Morrison Copper / Gold Project

Environmental Assessment Application – Response on Mount Polley Panel Recommendations

Morrison Copper/Gold Project Environmental Assessment Application - Response on Mount Polley Panel Recommendations

Figure 5.1 Filtered Tailings Facility – Plan

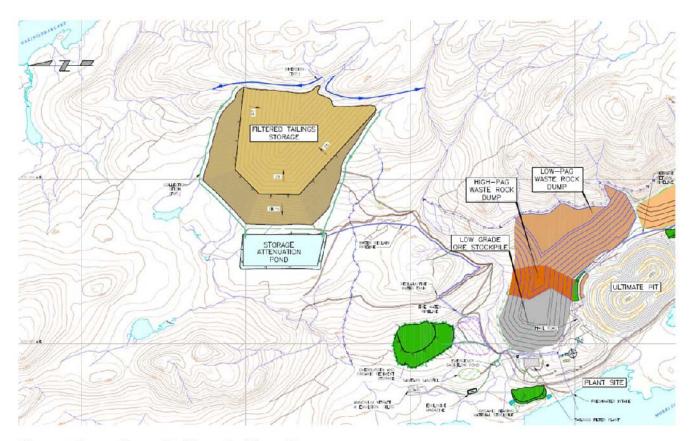
A conceptual scoping level assessment of applying the filtered tailings technology to the Morrison TSF was carried out to identify the potential technical benefits and challenges, and the potential costs. The assessment was based on a design life of 22 years to store 224 Mt of tailings. The tailings would be filtered in two streams: a) rougher NAG tailings – 85%); and b) sulphide cleaner PAG tailings -15%. The filter plants would be placed near the proposed plantsite and filtered tailings would be trucked to the TSF, which would be located within the eastern side of the currently proposed TSF.

A plan view of this conceptual layout is shown on Figure 5.1.
